RAI: Volume 3, Chapter 2.2.1.3.1, Second Set, Number 11:

Provide additional information to demonstrate the significance of salt separation effects on the timing and magnitude of radionuclide release from the proposed repository system.

Figure 1. Mean Fraction of Locations in Each Percolation Subregion That Will Experience Localized Corrosion Initiation after the Drip Shield Fails as a Function of Drip Shield Failure Time (SNL 2008, Figure O-2 of ERD05)

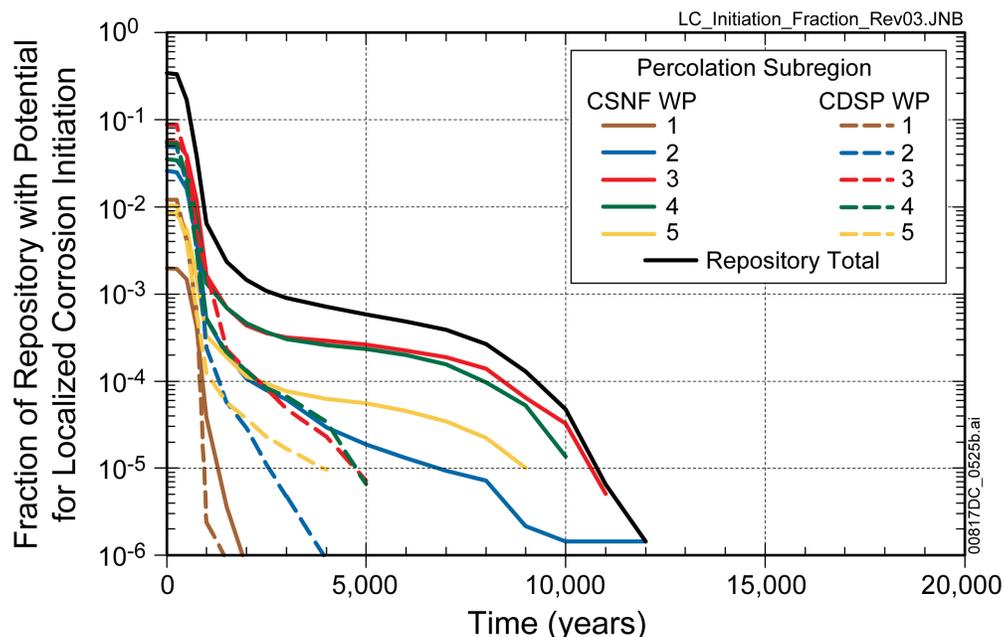
The main results of the localized corrosion initiation uncertainty analysis are shown in Figure 1. The results show the mean fraction of repository locations with the potential for localized corrosion initiation (either by salt separation or corrosion potential) as a function of the drip shield failure time. Note that there are two differences between these results and the results from the original analyses shown in Figure 2. The original analysis did not include salt separation. In addition, the original analysis only showed the instantaneous fraction of nodes where localized corrosion would initiate, whereas the updated results show the final fraction of nodes that would initiate, either immediately or in the future after the drip shield failure time.

In Figure 1, the effects of salt separation and corrosion potential are combined. The maximum of the mean fraction of nodes with potential for localized corrosion initiation is about 0.34. In contrast, Figure 2 shows the fraction of locations with potential for localized corrosion due only to electrochemical corrosion potential conditions. Because the maximum mean fraction of locations shown on Figure 2 is about 0.1, the mean fraction of locations with potential for localized corrosion due only to salt separation is roughly 0.24. The increase in the total number of nodes at which localized corrosion could initiate from 10% to 34% is due to inclusion of the salt separation process. However, salt separation only contributes to the potential for localized corrosion initiation for about 1,000 years. Beyond 1,000 years, the relative humidity at the waste packages rises above the precipitation threshold, thus precluding future salt separation on the waste package surface. Consequently, after 1,000 years, Figure 1 and Figure 2 are quantitatively similar and show only the effect of the electrochemical corrosion potential because salt separation can no longer occur. The numbers in the two figures are slightly different, again, because Figure 2 shows only instantaneous values whereas Figure 1 also includes waste packages on which localized corrosion initiates at some time after drip shield failure.

As indicated by Figure 1, the conditions for any type of localized corrosion initiation do not occur beyond 12,000 years. If the drip shield remains intact for 12,000 years, localized corrosion of the waste package will not occur.

Figure 3. Expected Annual Dose over 10,000 Years from Seismic Ground Motion Events That Result in Drip Shield Plate Failure Including Salt Separation (SNL 2008, Attachment 2 of ERD 05)

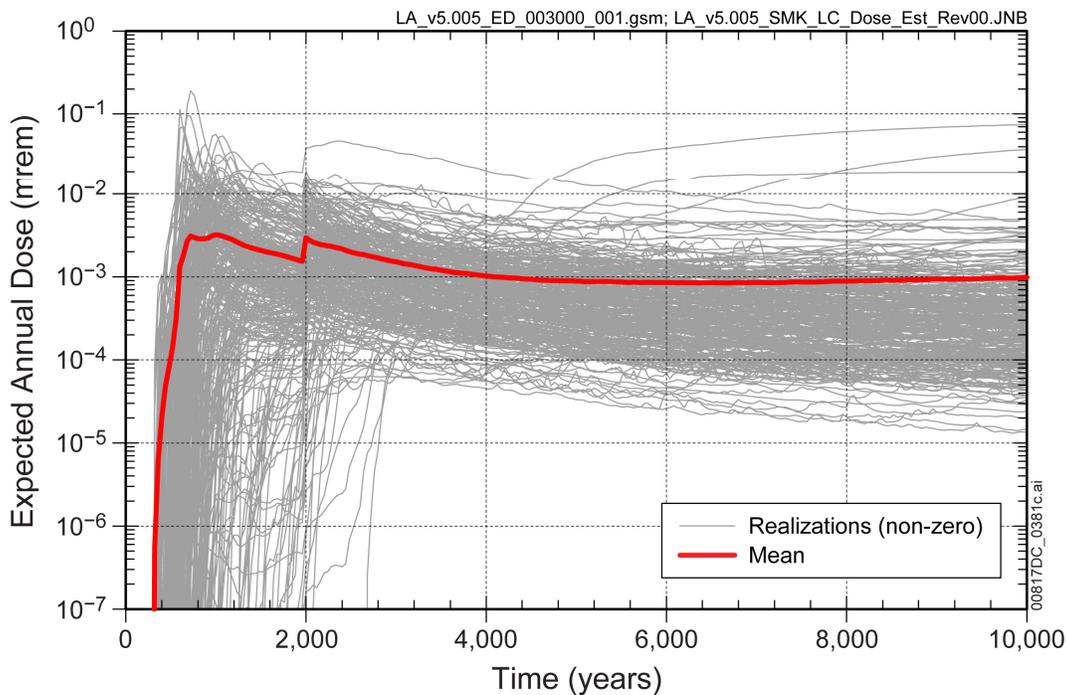
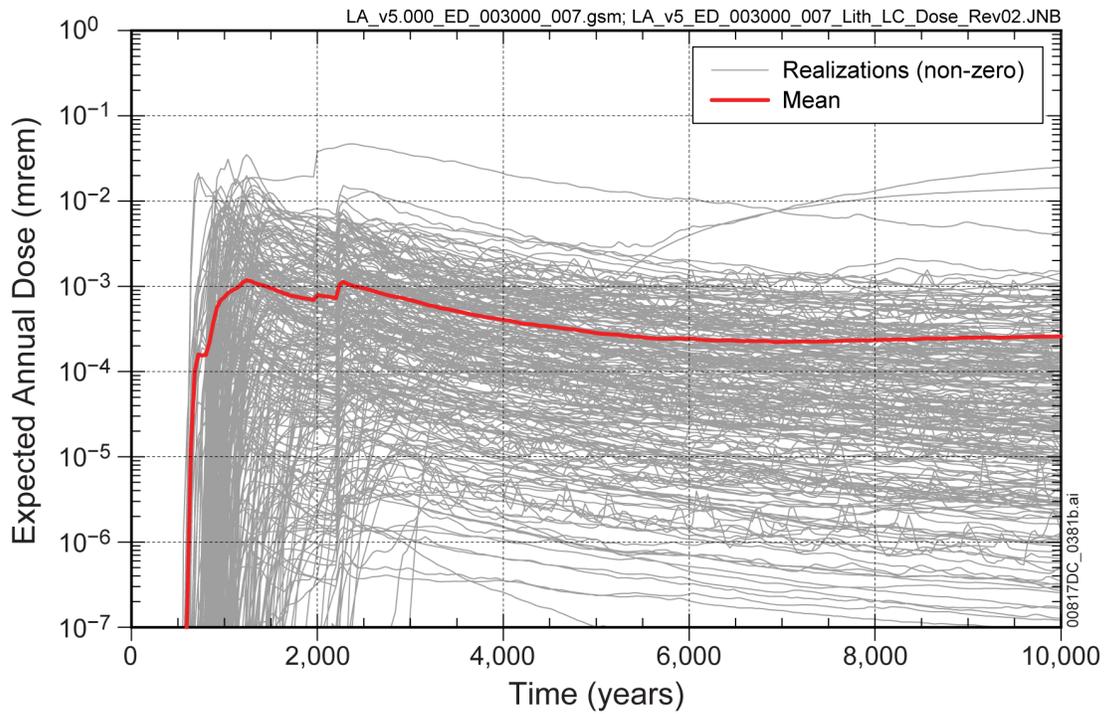
Figures 3 and 4 show the 10,000-year distribution of expected annual dose from seismic ground motion events that result in drip shield plate failure, and compare the original results (without salt separation) to the updated results (with salt separation). The effect of including salt

separation can be observed in several aspects: the earlier rise time of the expected annual dose (mean appearing just before 500 years instead of just after); a greater maximum in the mean annual dose by about a factor of three; and a narrower distribution of results due to increases in the lower range of the distribution.

To determine whether the contribution to expected annual dose from the combination of drip shield failure and localized corrosion of the waste package is significant, the mean annual dose from Figure 3 is compared to the mean annual dose from the seismic ground motion modeling case for 10,000 years post-closure (SAR Figure 2.4-25a, reproduced here as Figure 5). The distribution of expected annual dose shown in Figure 5 results from considering only the annual dose resulting from seismically induced damage (i.e., stress-corrosion cracking) of co-disposal waste packages. The comparison between Figure 3 and Figure 5 shows that the mean annual dose considering drip shield failure and localized corrosion is substantially less than the mean annual dose calculated in the seismic ground motion modeling case, except just before 1,000 years post-closure. From about 800 to 1,000 years post-closure, the initial peak of the mean annual dose from the combination of drip shield failure and localized corrosion of the waste package rises to about 3×10^{-3} mrem, and is somewhat greater than the mean annual dose in the seismic ground motion modeling case. However, after 1,000 years post-closure the mean annual dose in the seismic ground motion modeling case significantly exceeds the mean annual dose from the combination of drip shield failure and localized corrosion of the waste package. Most importantly, the mean annual dose considering drip shield failures is less than 5×10^{-3} mrem during 10,000 years, which is not numerically significant compared to the maximum mean annual dose in the seismic ground motion modeling case for 10,000 years (about 0.2 mrem). Thus, inclusion of salt separation in the localized corrosion initiation uncertainty analysis has a negligible effect on the results of the seismic ground motion modeling case for 10,000 years post-closure.

The results shown in Figure 3 are also applicable when considering the potential effect of localized corrosion on the seismic ground motion modeling case for 1,000,000 years. The same qualitative conclusion is reached here as in the 10,000-year period (compare Figure 3 with SAR Figure 2.4-25b), in that the contribution to the mean annual dose from the combination of drip shield failure and localized corrosion is not significant during the first 10,000 years post-closure. The fully probabilistic seismic ground motion modeling case for 1,000,000 years considers the combined effects of general corrosion of drip shield materials and of seismic events (e.g., drift degradation) to determine the time of drip shield failure. The results of this modeling case show that no drip shield failures are estimated to occur before 12,000 years (SNL 2008, p. 8-66[a] and Figure 8.3-7[a]), and consequently inclusion of salt separation has no effect on the mean annual dose for this modeling case.
